JULY 30, 2025

CONTRACT NO. 1800

WET WEATHER PUMP STATION

ADDENDUM NO. 6

430-A-09
ELECTRICAL AND HVAC FLOOR PLAN
SOUTH

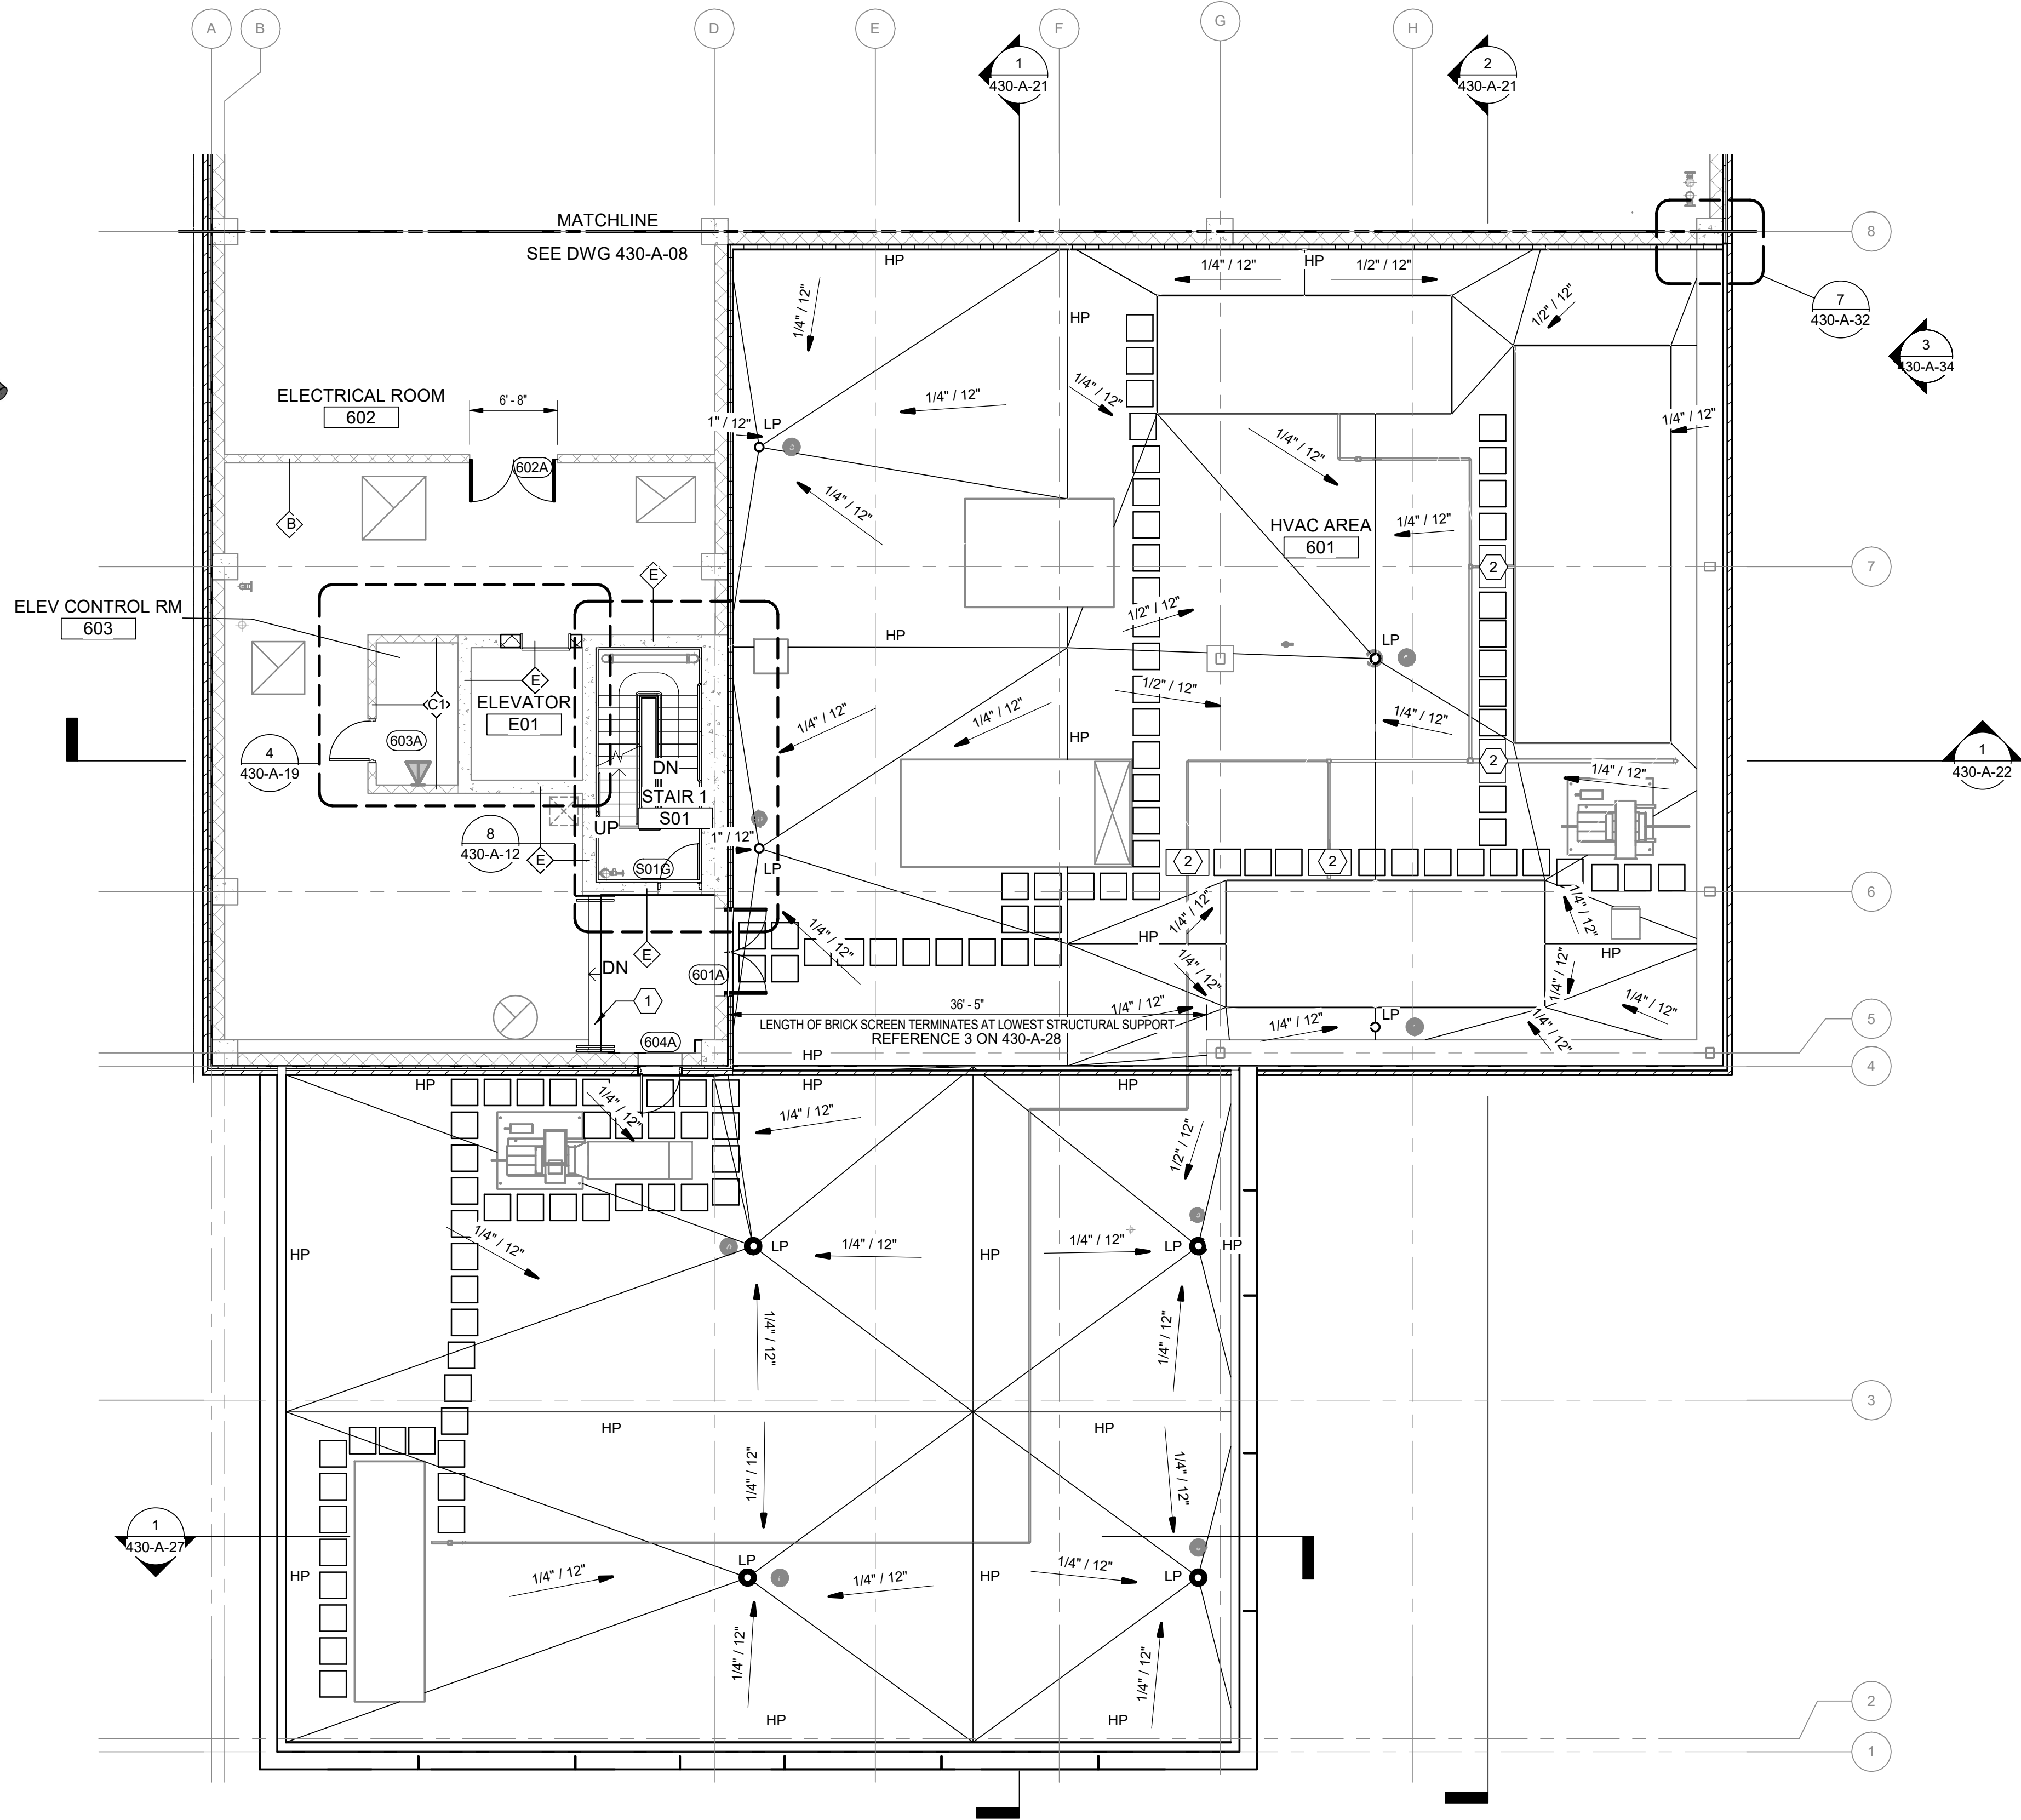
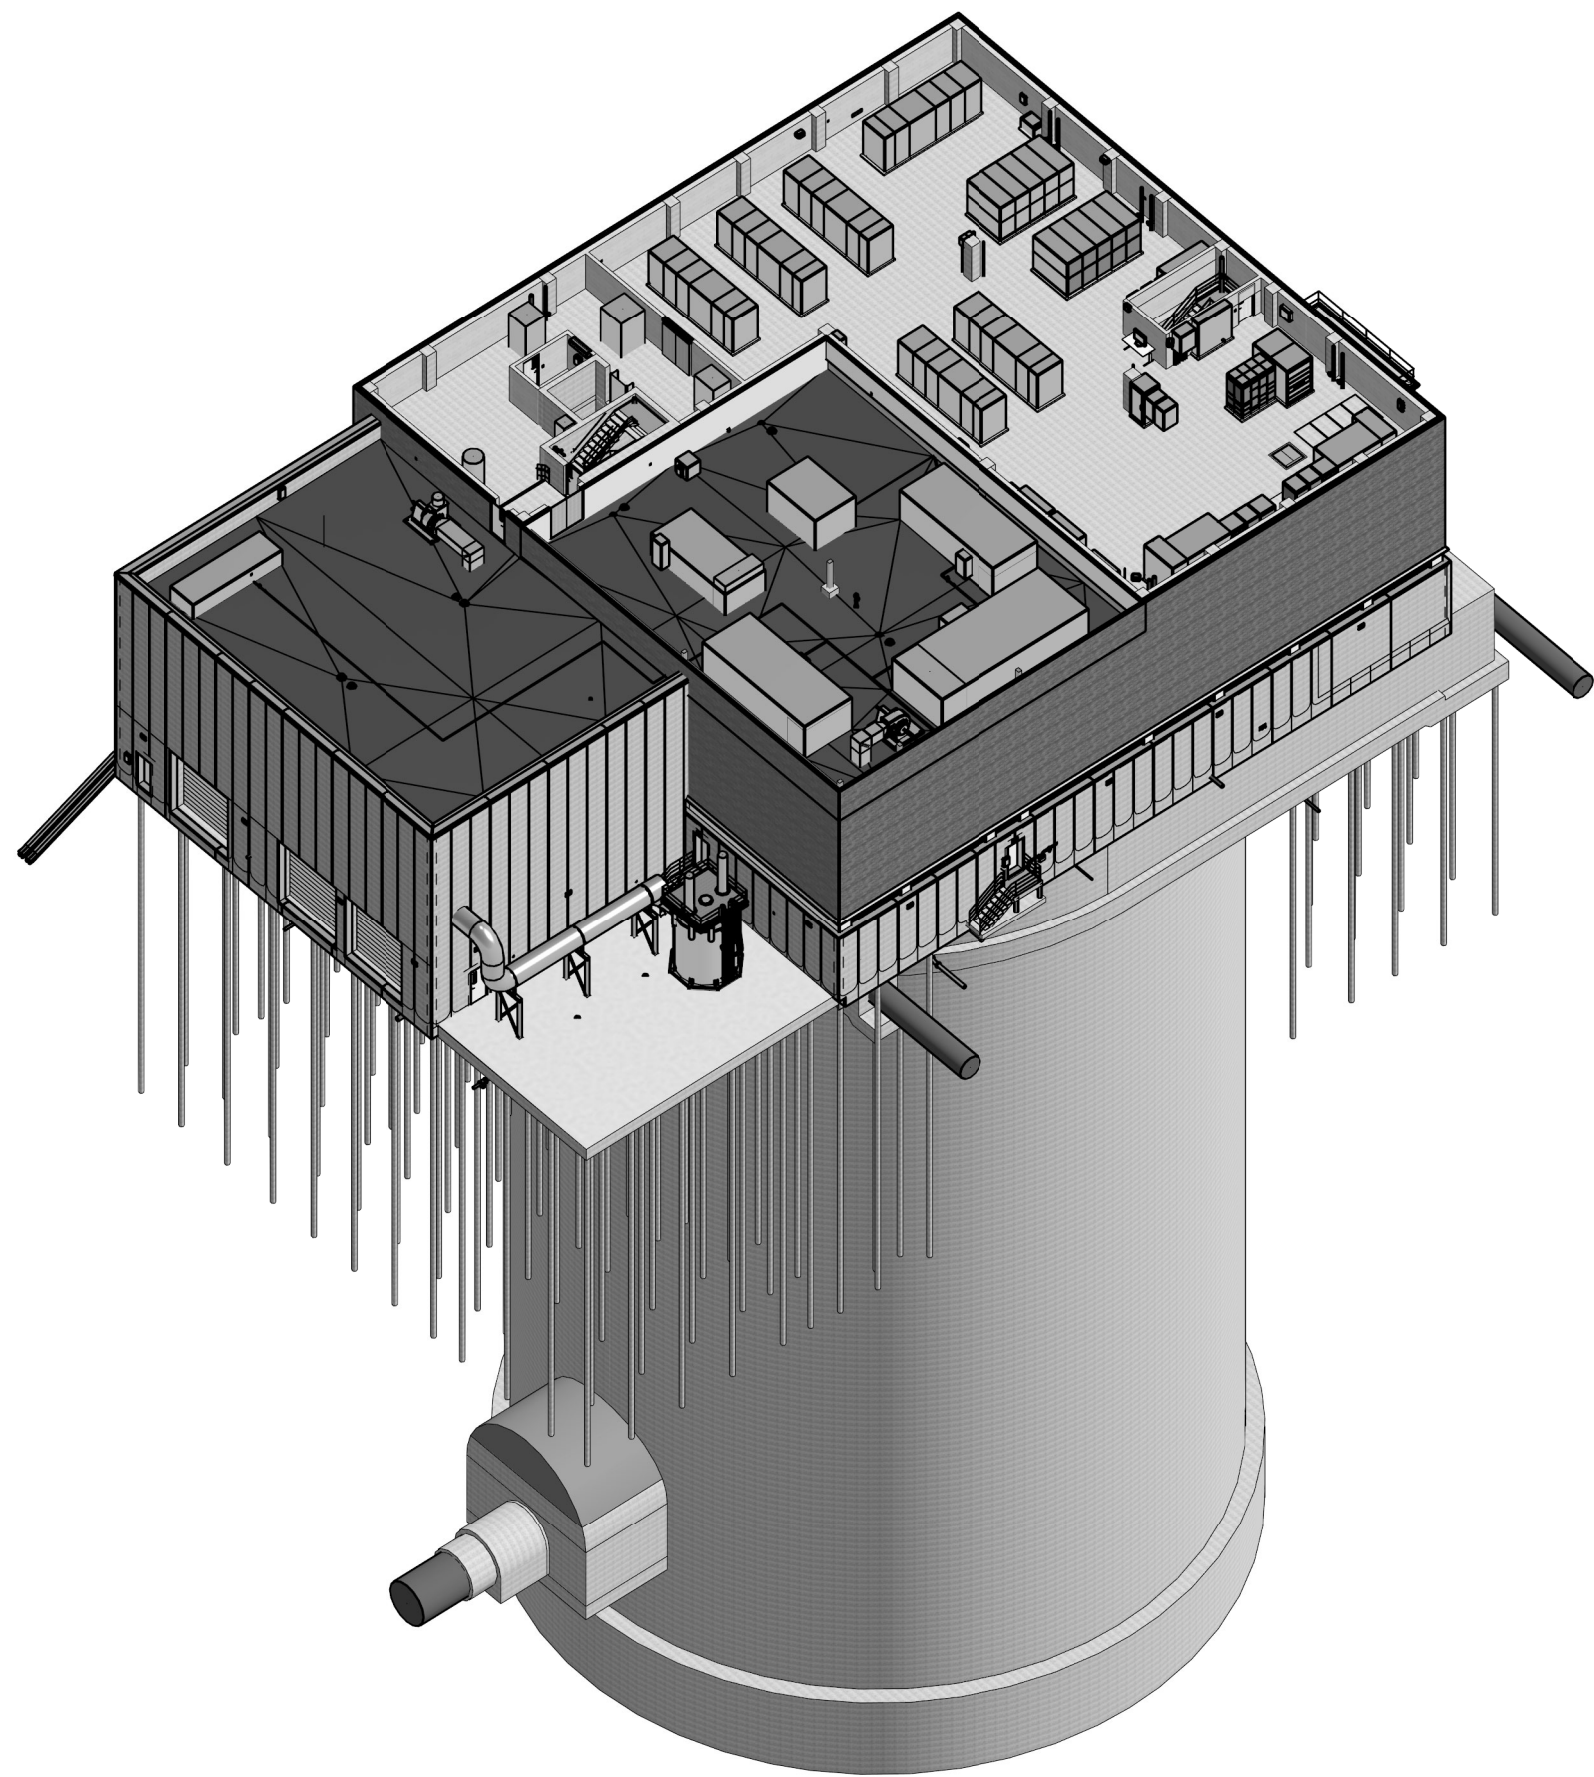
- 4.1 **REPLACE** Sheets 430-S-47 and 430-S-48 with Sheet 430-S-47 Rev. 01 and 430-S-48 Rev. 01, refer to Attachment C.
- 4.2 **REPLACE** Sheets 430-A-09, 430-A-20, 430-A-28, 430-AS-01, and 430-AD-09 with Sheets 430-A-09 Rev. 01, 430-A-20 Rev. 01, 430-A-28 Rev. 01, 430-AS-01 Rev. 01, and 430-AD-09 Rev. 01, refer to Attachment C.

Q49: Drawing 430-A-09 General notes 2: Cross over stairs at pipes. Please provide detail of the cross over stairs.

Q12: Specification 07 10 50, 1.05 Quality Assurance, B. Field samples and testing, 2. "single weld samples, three-foot long, from each welding machine and welder, prior to start of shift are required." this requirement is typical when using an automatic welding machine. Is it the engineer's intent to require 3' samples at the beginning of each shift when seam welding is performed by hand with a heat gun?
